## Public Comment Submission on WaterSense Documents

**Commenter Affiliation:** Appliance Standards Awareness Project

**Topic:** Specification for private lavatory faucets (non-metering)

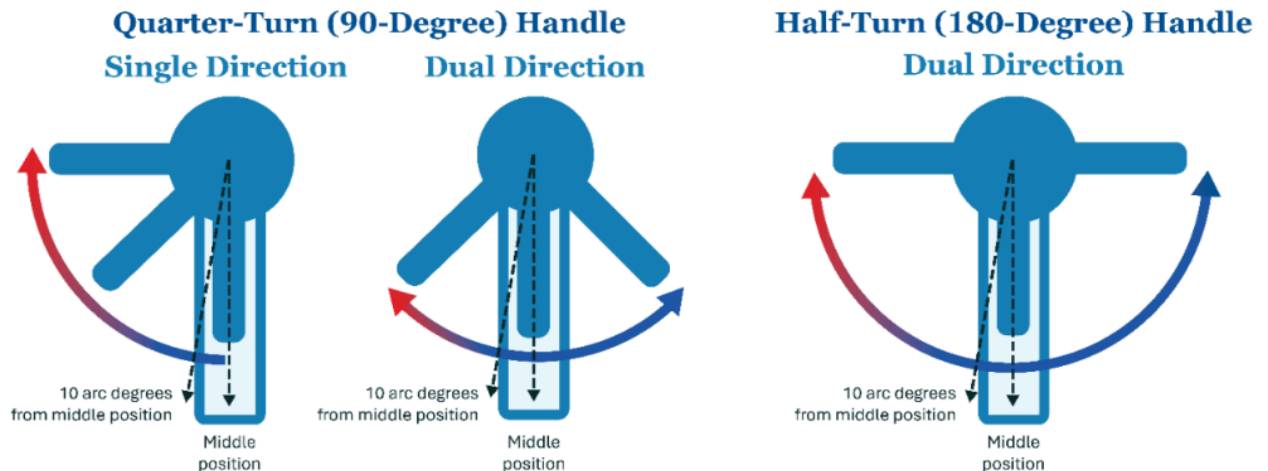
**Topic:** Cold-start faucet criteria

**Comment:** We support the optional criteria for cold-start faucets.

**Rationale:** The proposed cold-start criteria will identify faucets that not only meet WaterSense, conserving water, but that also incorporate an energy saving design. A faucet with this design will have a default ('middle') position that delivers only cold water. This design requires the user to position the faucet handle away from the middle position before hot water flows. The optional cold-start criteria will therefore help consumers be able to choose faucets that save water while also saving energy. We also support the proposed temperature labeling on the faucet. The proposal, which requires an indicator that the middle position only dispenses cold water, will provide consumers guidance on the temperature of the water, so that they are better equipped to interact with a product with this energy-saving design.

**Suggested Change (or Language):** In section 4, we recommend specifying 'handle' instead of 'lever' to remain consistent with the language in the test method in Appendix C.
